Project Comment Form

Multicare Good Samaritan Hospital

Project Title: Center Wing AHU Replacement

Note: Clarify the detail on sheet TM4.01.

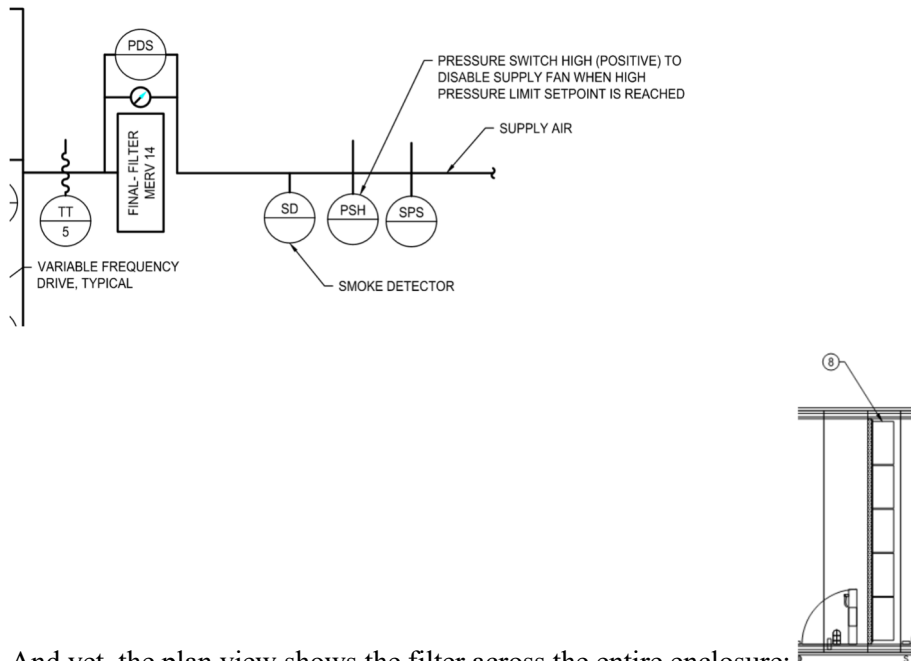
This shows the ductwork connecting to the final filter but not going thru it. It shows the air flow going around it.

And yet, the plan view shows the filter across the entire enclosure:
